**CALIFORNIA COASTAL COMMISSION**

**STAFF REPORT: REGULAR CALENDAR**

**APPLICATION NO.:** 4-99-211

**PROJECT LOCATION:** 28827 Grayfox Street, City of Malibu, County of Los Angeles

EXHIBIT NO. 5 (11)  
 APPLICATION NO.  
*Level*  
 4-99-211  
 Project Plans

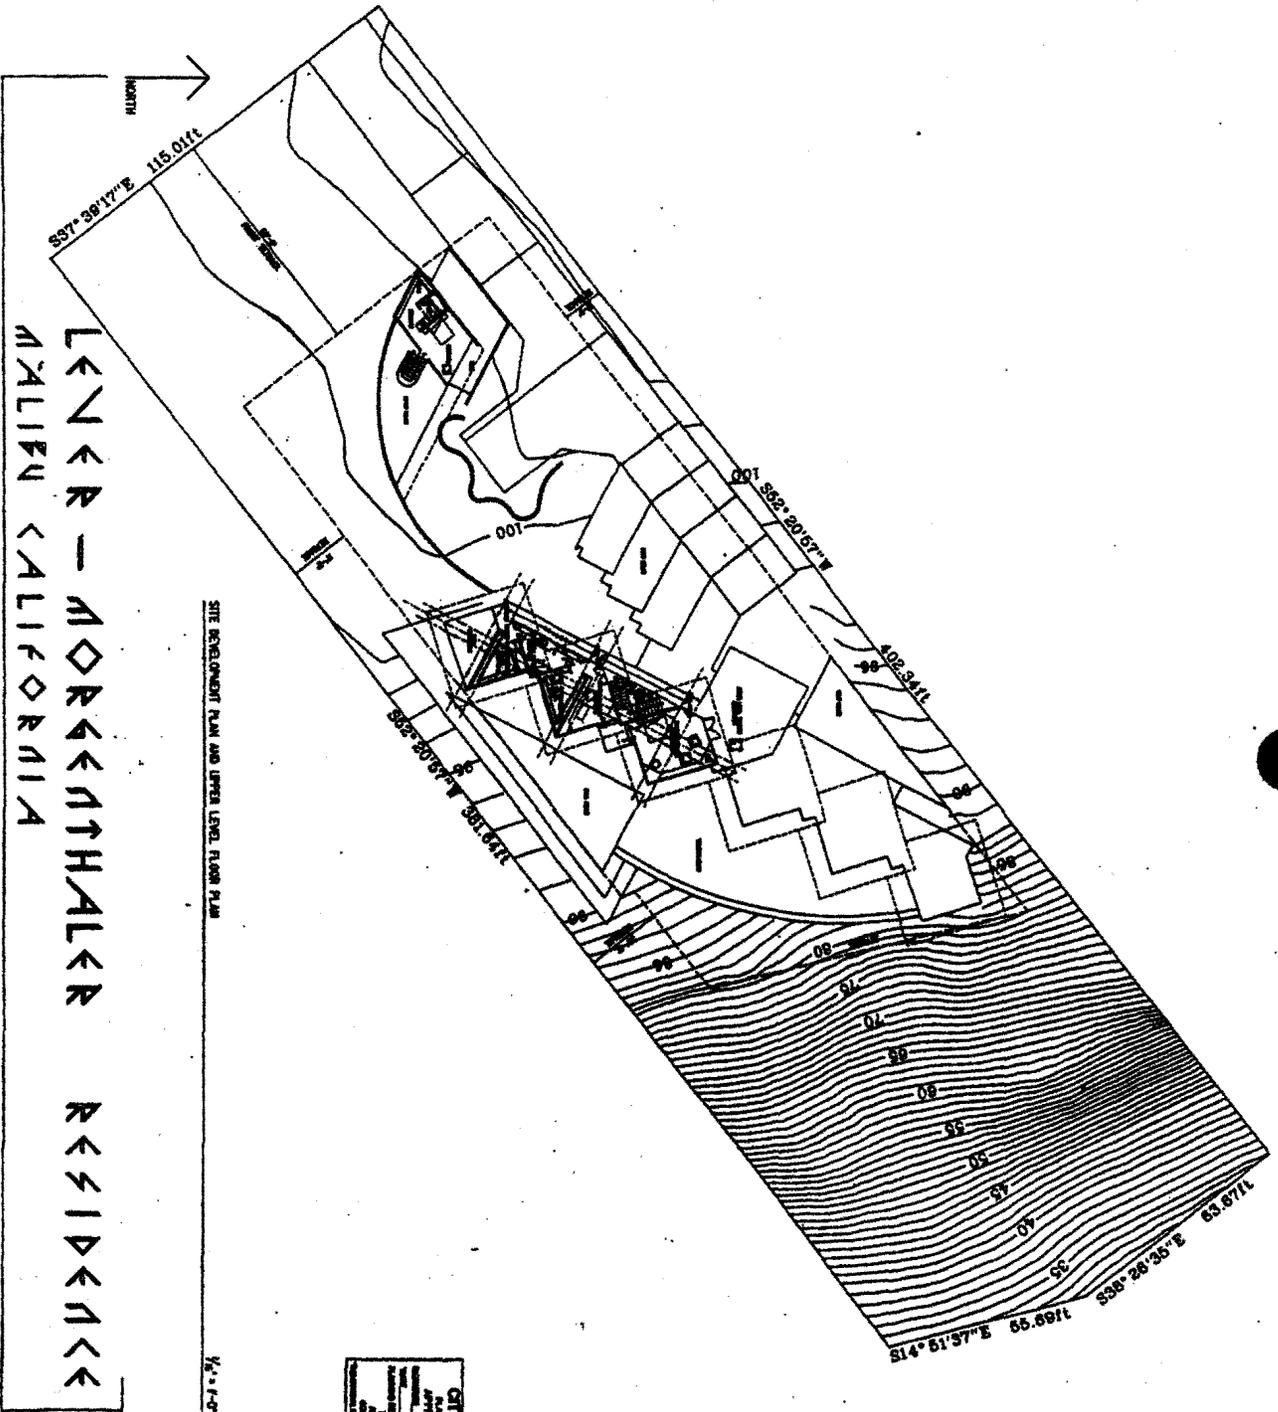
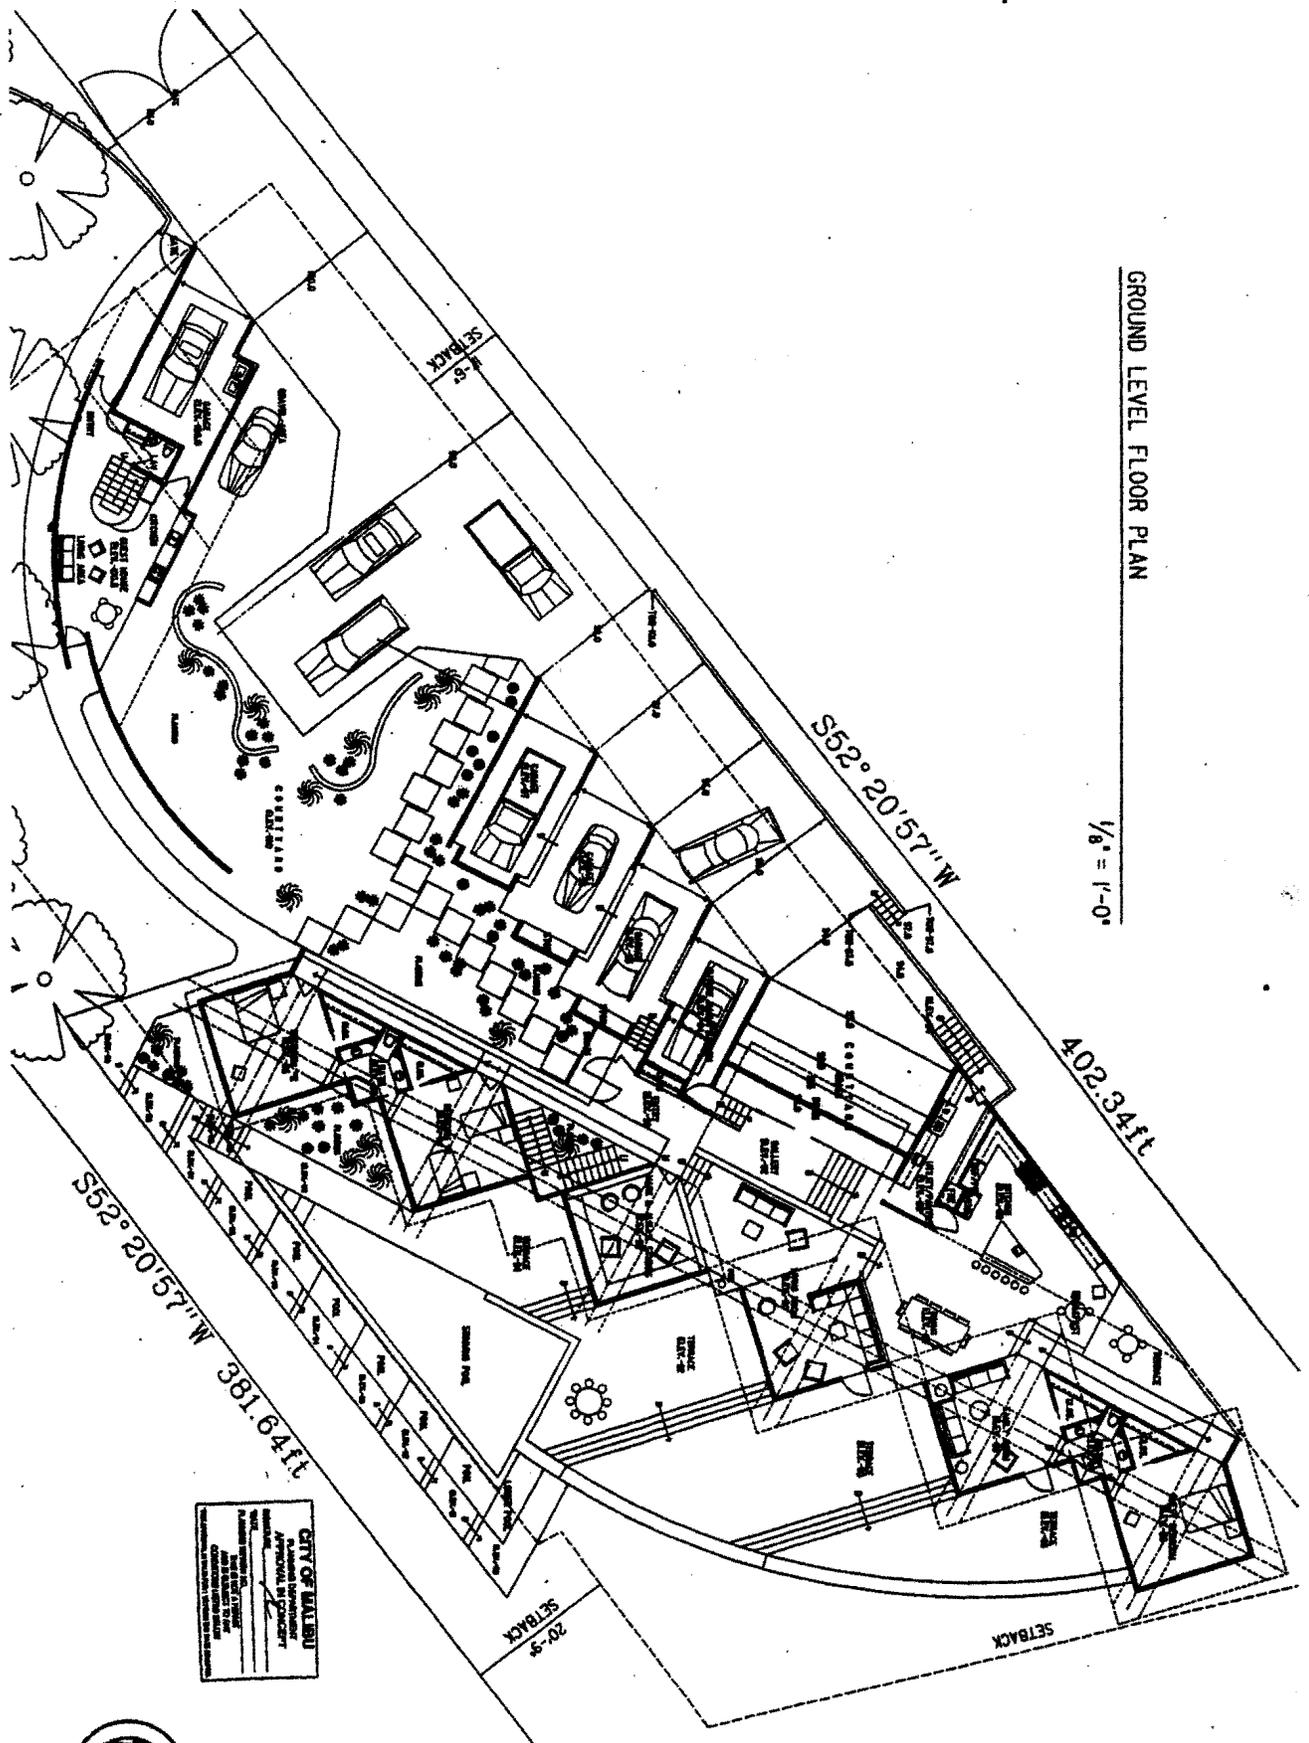
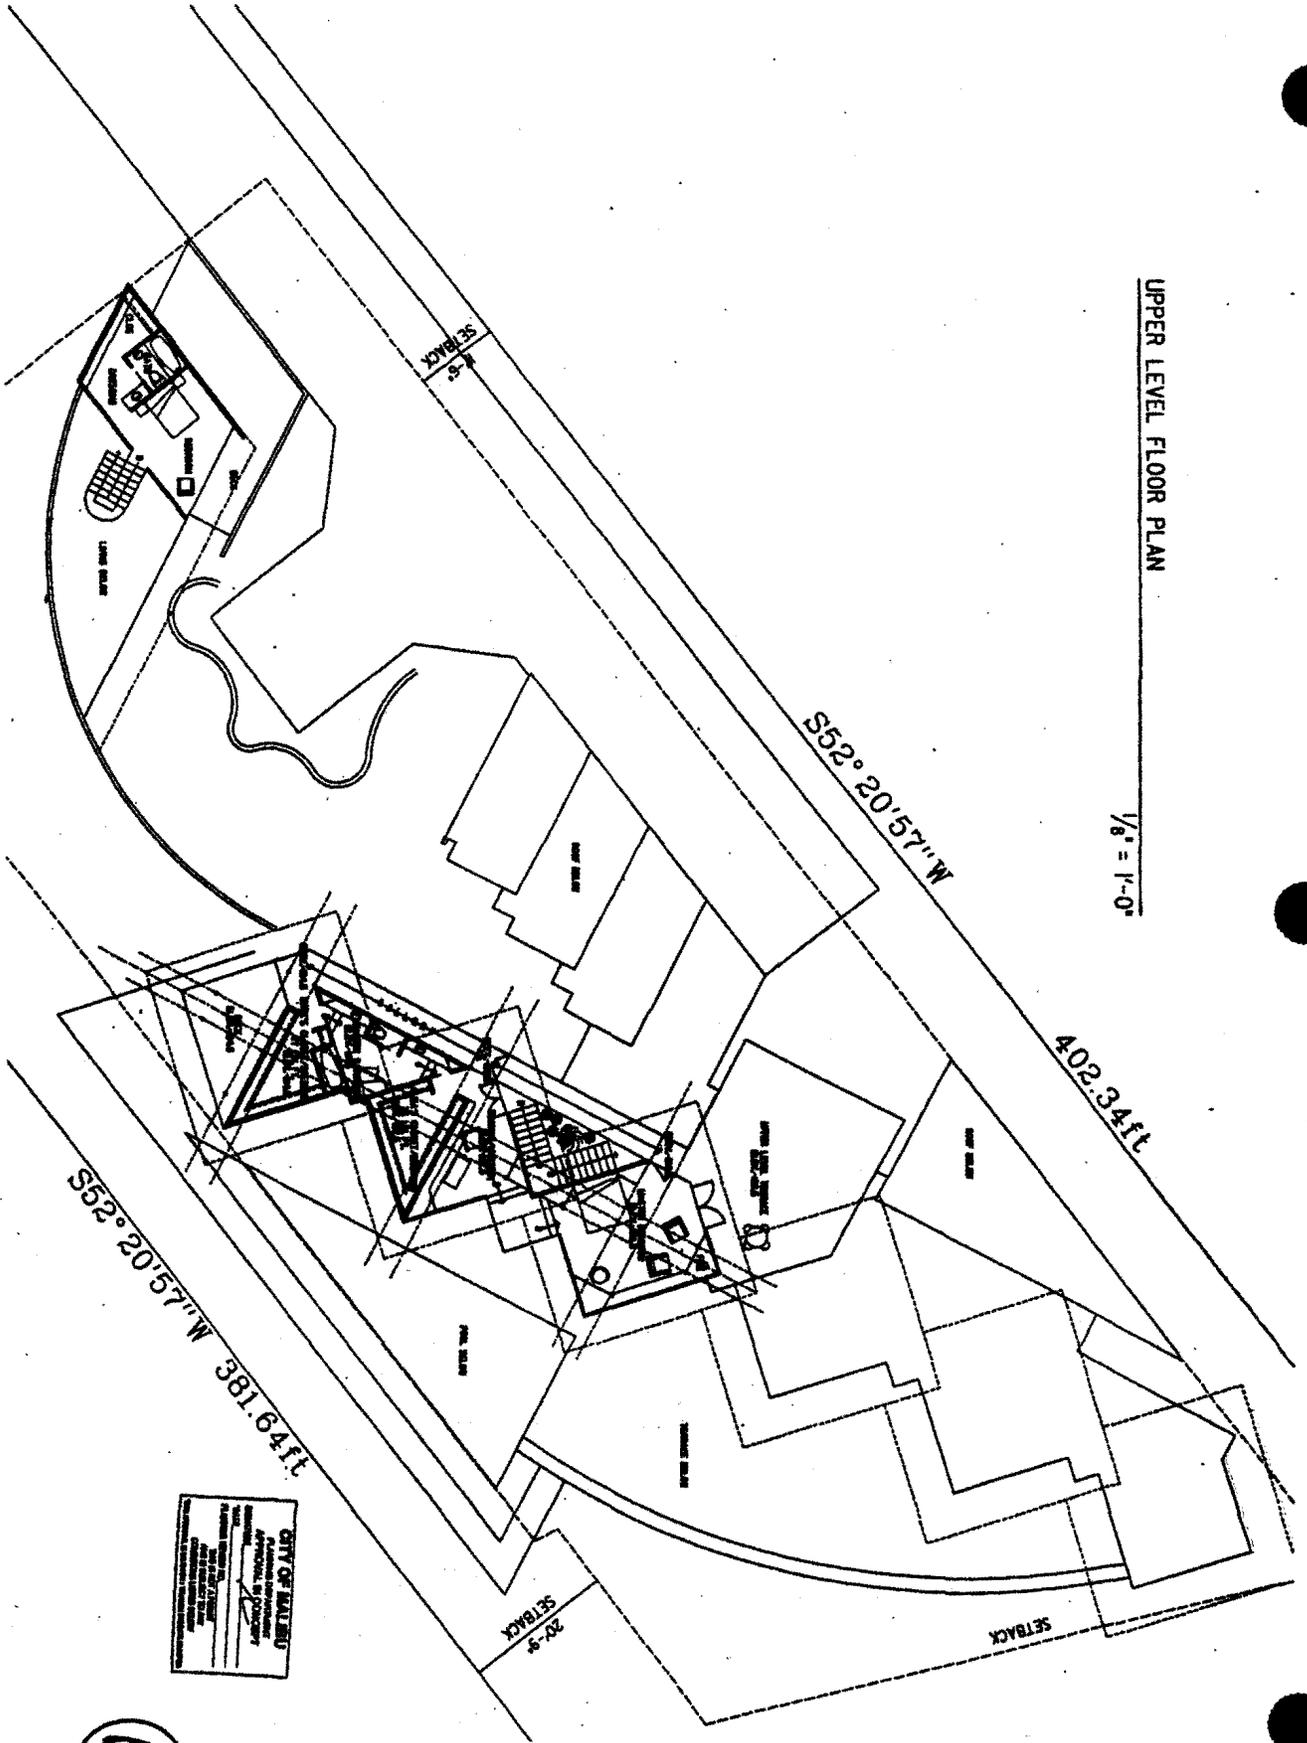
The applicant has been notified that discrepancies exist between the project described in the application and the actual to-scale plans on file. Revised plans have not been submitted, therefore the project described herein is the project shown on the to-scale plans, including the grading plan, on file.

Specifically, the application states that the proposed guest unit is 750 sq. ft.; however the plans show that the unit would be 762 sq. ft. The Commission notes guest units in the Malibu/Santa Monica Mountains are limited to a maximum of 750 sq. ft., and if the subject proposal were recommended for approval, revised plans would be necessary to bring the proposed second unit into conformance with this requirement.

EXHIBIT NO. 13a
APPLICATION NO. Level
4-99-211
"Top-of-Slope"

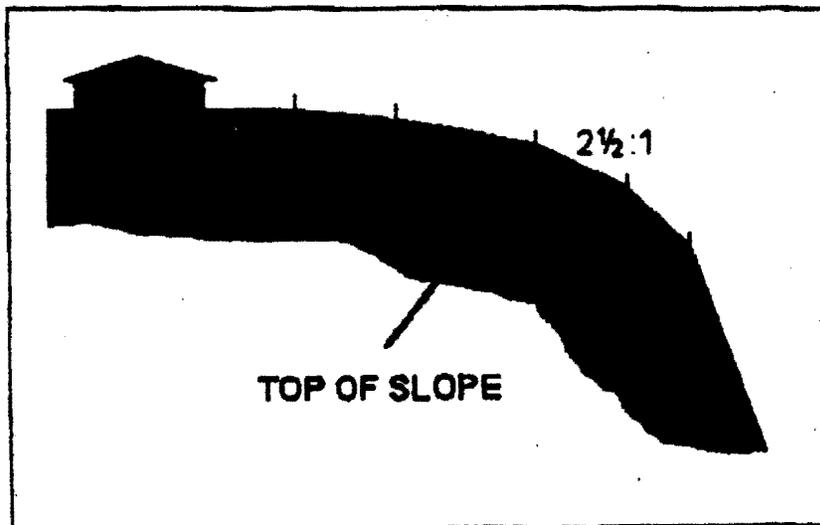
Less than one month after the July survey, the applicant obtained a copy of a memorandum dated August 6, 1998 by City Planning Director Craig Ewing to his staff regarding the determination of top-of-slope. The memorandum directs staff that where a site has two distinct slope segments descending into a canyon (such as the applicant's site) if the slope aspect of the upper segment does not exceed 4 (horizontal):1(vertical) then the lower slope break will define top-of-slope.
